OG # 23-044_HPA # 23-072

Project Address: 3615 Prospect Street NW

Project Description: replace roof, windows, siding, and fence; install guardrail at rear

CONCEPT SUBMISSION

A002
EXISTING
FLOOR PLANS

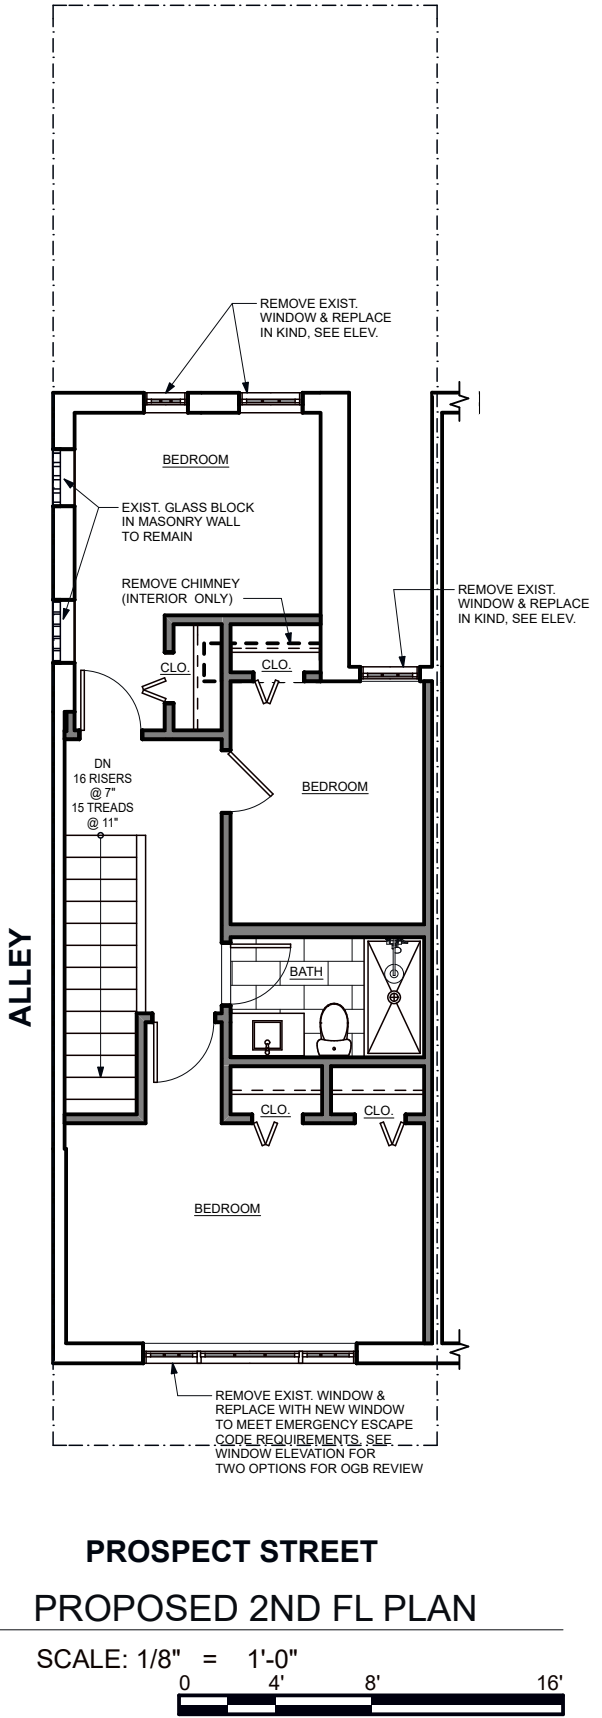
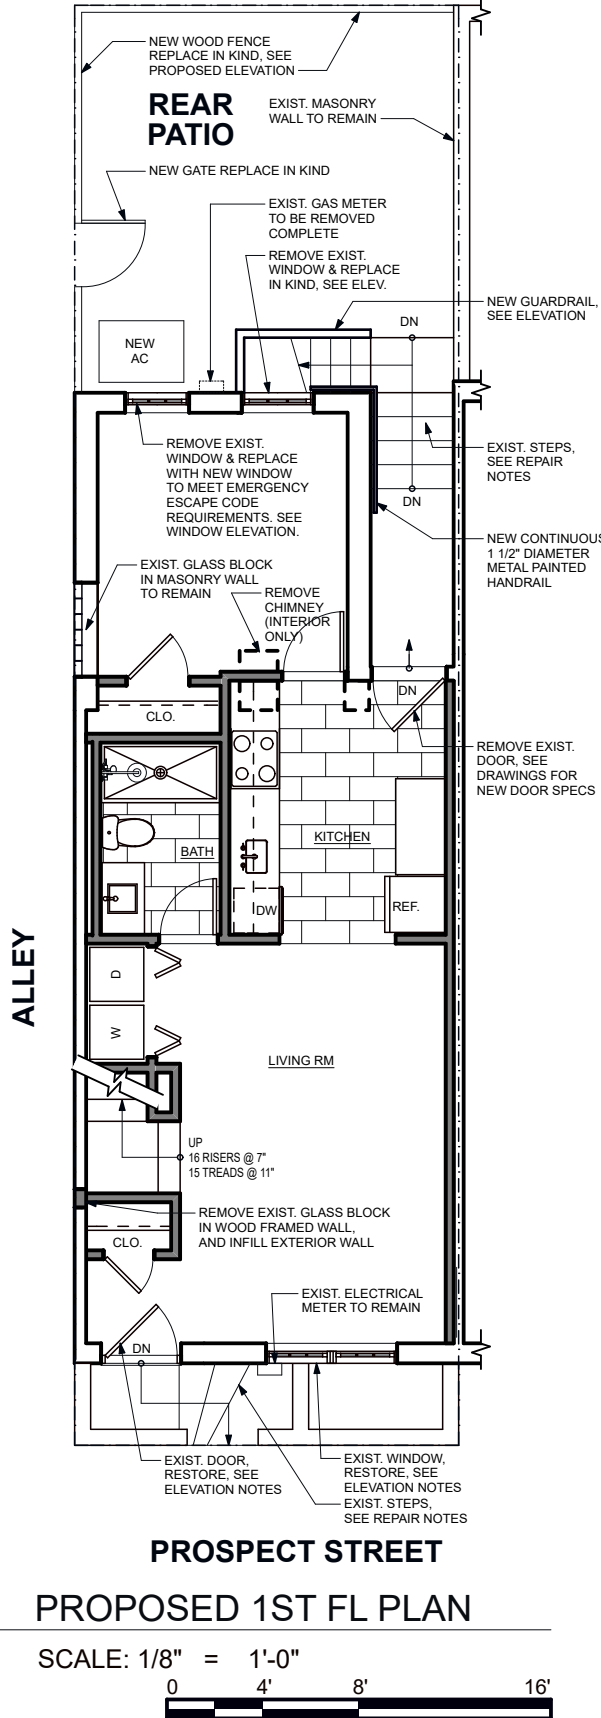
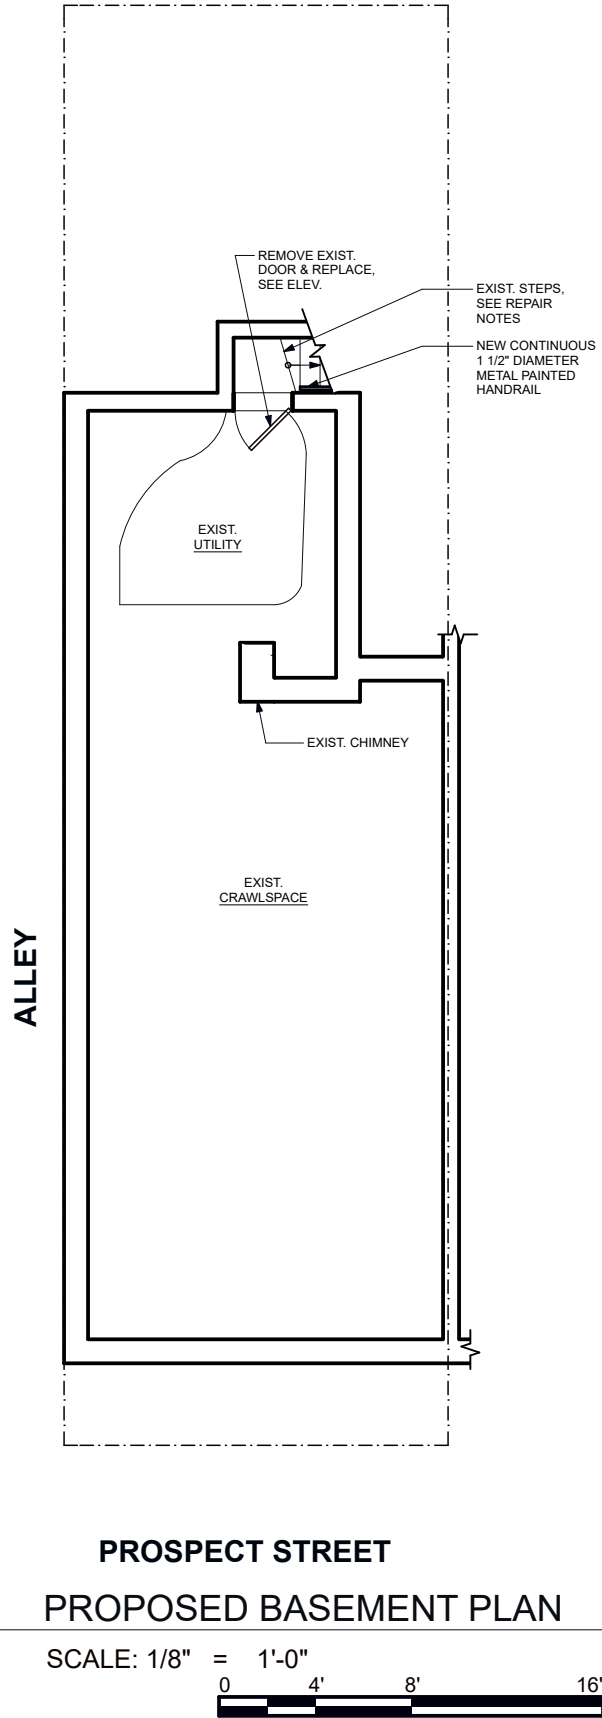
1. For projects with broad scopes of work, the Board members like to see floor plans so they can understand the project as a whole. So please include existing and proposed floor plans in the package. **RESPONSE: SEE SHEETS A002 AND A003.**

5. Please add a note on A002 clarifying that the roof, gutters, and downspouts will be replaced. **RESPONSE: ADDITIONAL NOTES HAVE BEEN ADDED TO SHEET A002.**

WINDOW REPLACEMENT OPTIONS - 2ND FL PROSPECT ST

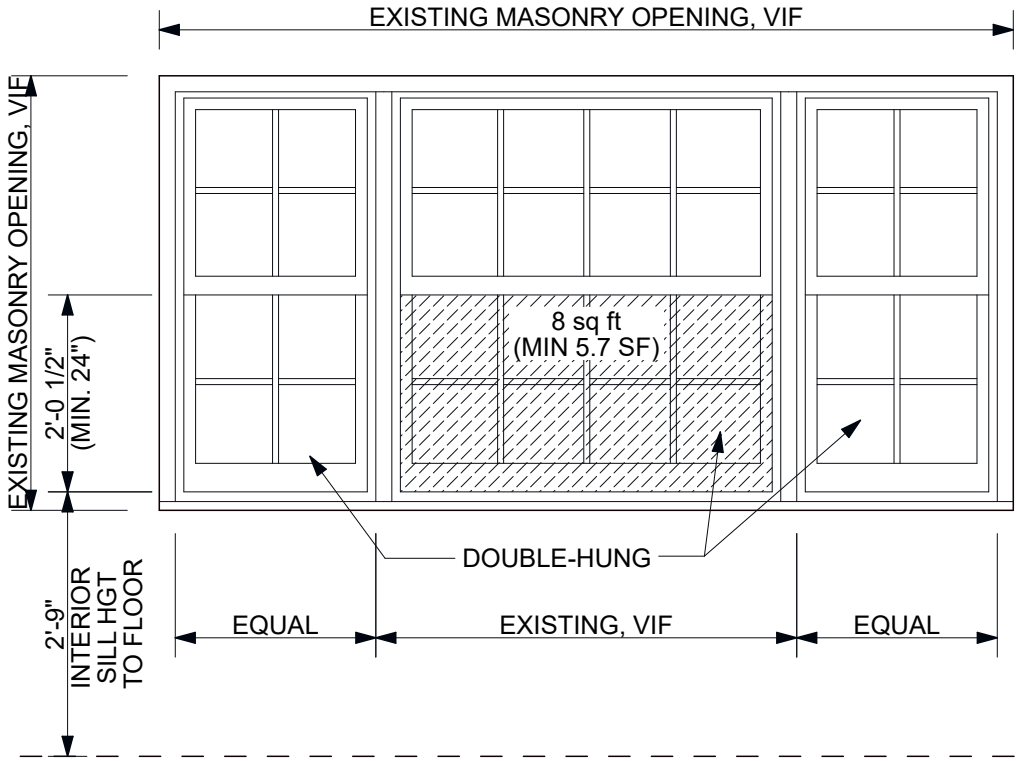
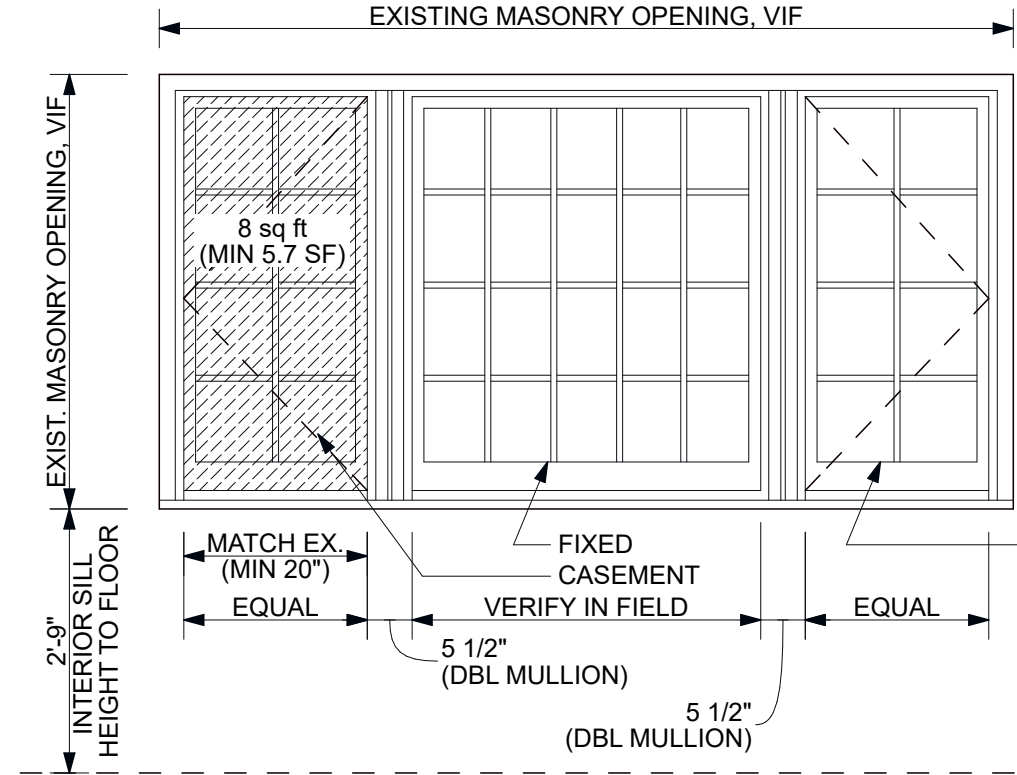
3. Thank you for including options for the window replacement on the front. I'm providing a photo from the 1990s that shows what the windows probably looked like when they were installed (the date of the installation of the brick cladding and window opening alteration is unclear, but this photo appears to show those original replacement windows). The configuration and proportion of the lites is pleasing, and the detailing for the two mullions works well with the design, so I wonder if you might consider revising one of the options to show this (or adding a third option). **RESPONSE: OPTION B HAS BEEN REVISED TO MORE CLOSELY MATCH THE CONFIGURATION IN THE PROVIDED PHOTO. THE CENTER LITES WERE REVISED AND AN ADDITIONAL MULLION WAS ADDED BETWEEN THE FIXED WINDOW AND THE CASEMENT WINDOWS. SEE SHEET A010.**

A011
PROPOSED
REAR
ELEVATION &
FENCE

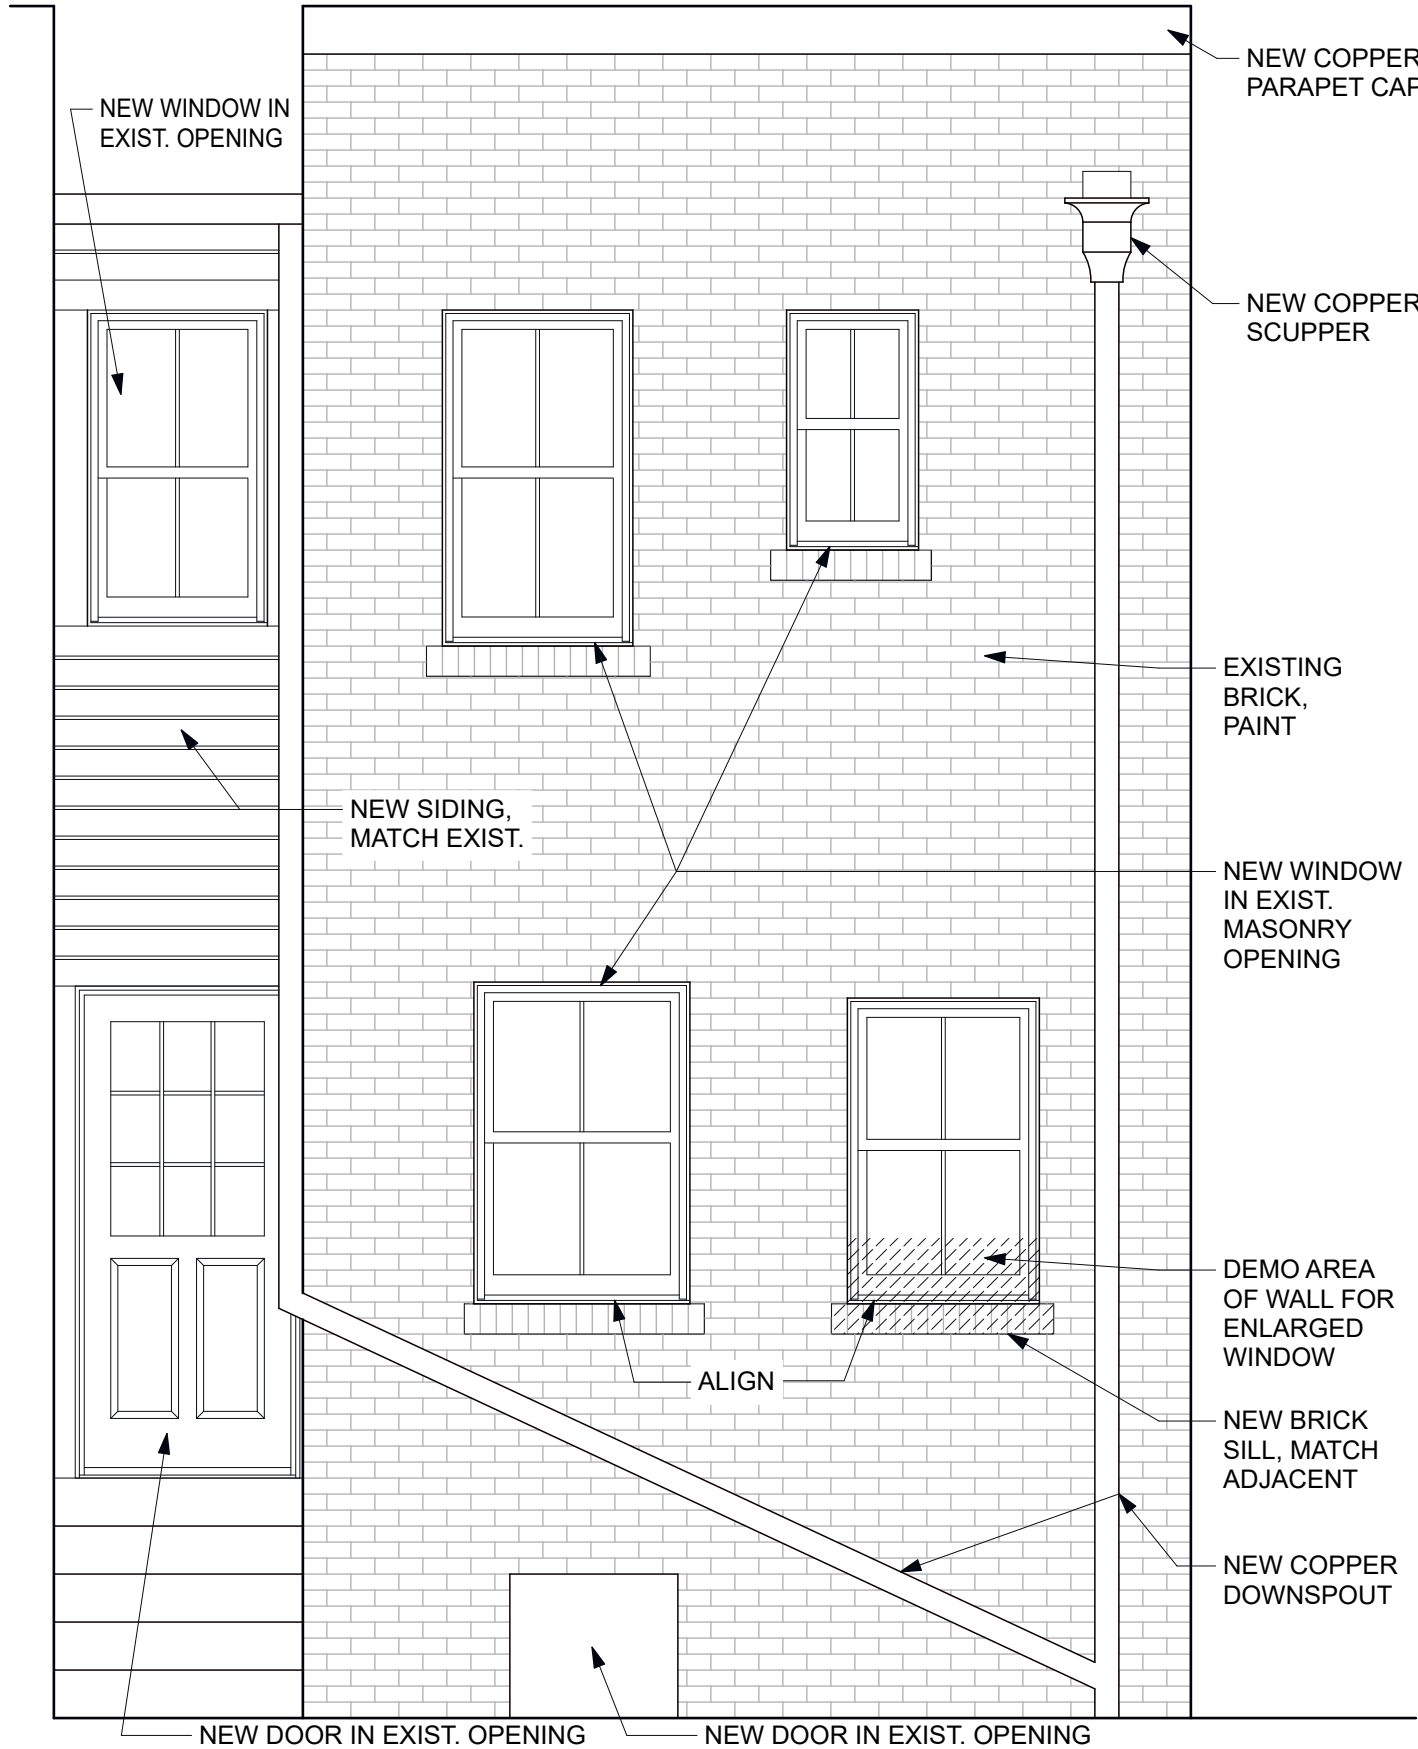
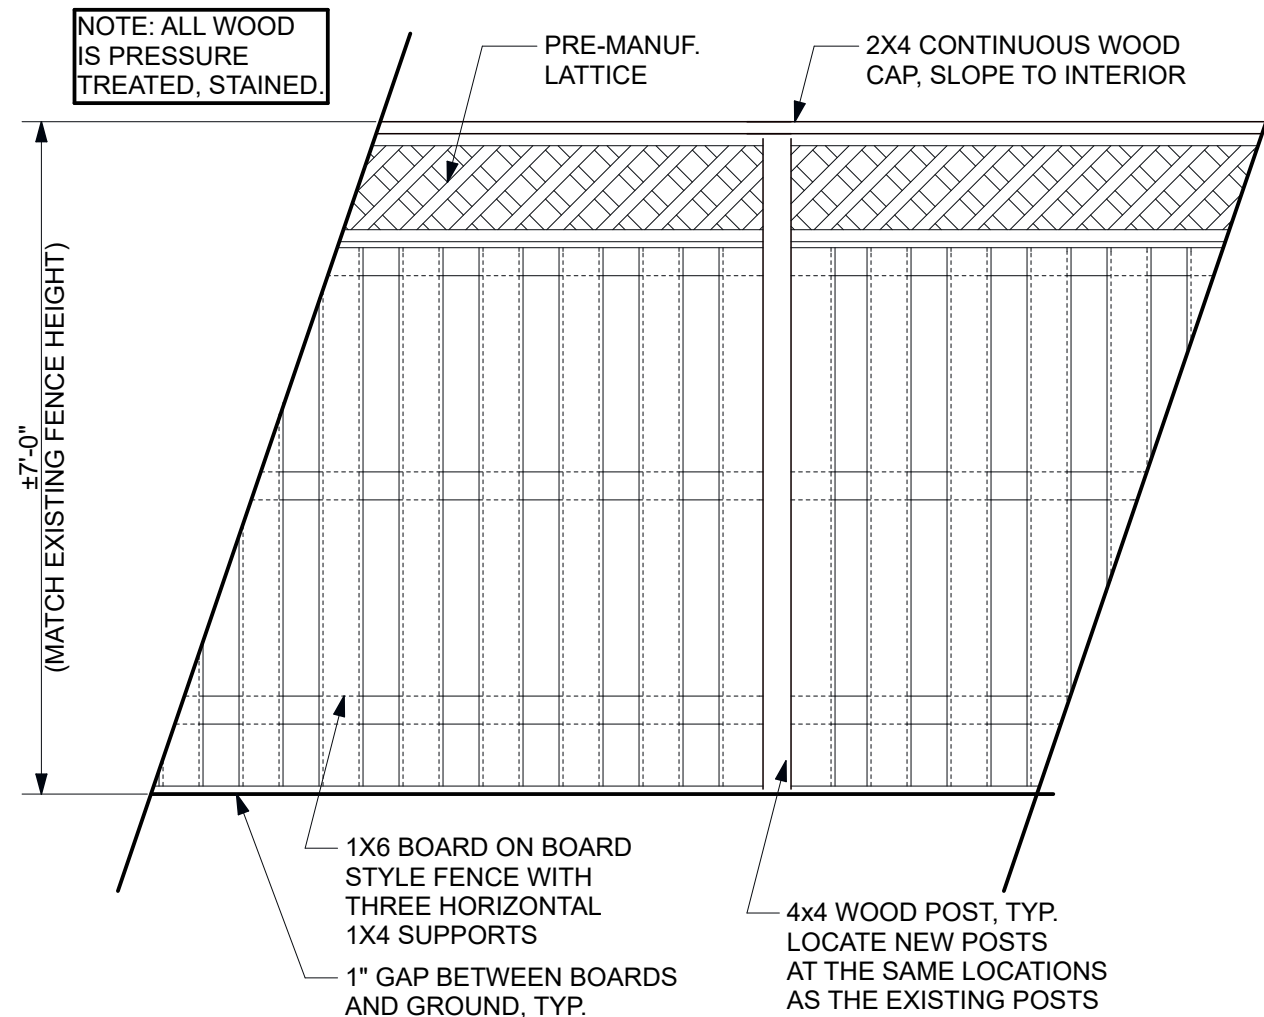
4. For the rear window details, please include existing and proposed detailed elevations and sections, showing accurate lite configurations and proportions. We need to understand that the trim would match that of the adjacent window. also include the wall in the section drawings. Also, only half-screens are approved, so please revise. **RESPONSE: NO SCREENS ARE PROPOSED.** I must also note that the Board has not support aluminum-clad windows in the past, and fiberglass has been approved only in special circumstances. We can still get their feedback from the Board on this item, but I wanted to let you know in advance. **RESPONSE: THE REAR WINDOWS HAVE BEEN CHANGED TO ALL WOOD, HOWEVER WE ARE STILL PROPOSING DOUBLE PANE. SEE SHEET A011 and A012.**

6. Please include measurements and material notations for the proposed fence. **RESPONSE: THE DESIGN INTENT OF THE NEW FENCE IS SHOWN ON SHEET A011.**
